The Parker – 13th and Bainbridge

Art Opportunity – Request for Qualifications Responses to questions received by July 17, 2023

SK-1

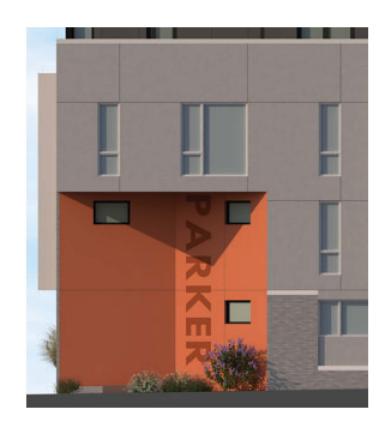
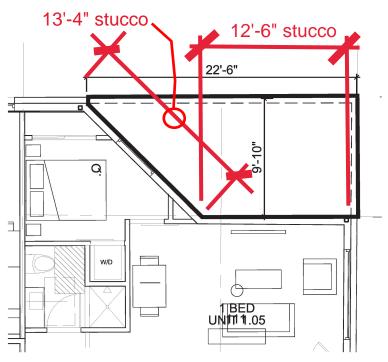
- A4: More detailed information about the building and site will be provided to artists invited to participate in the request for proposals stage.
- Q5: In the RFQ, the exterior dimensions and the height of the space are clearly marked, but we are curious about the interior dimensions of the walls that will receive surface treatment, as well as measurements for the window cut outs?

- A5: See attached drawing.
- Q6: We are excited about the community's interest in making the space "a destination." Will we be able to bolt site-specific furniture or structural elements into the ground, foundation, and/or walls of the building?

"J" Window is 4'-0" wide x 2'6" high
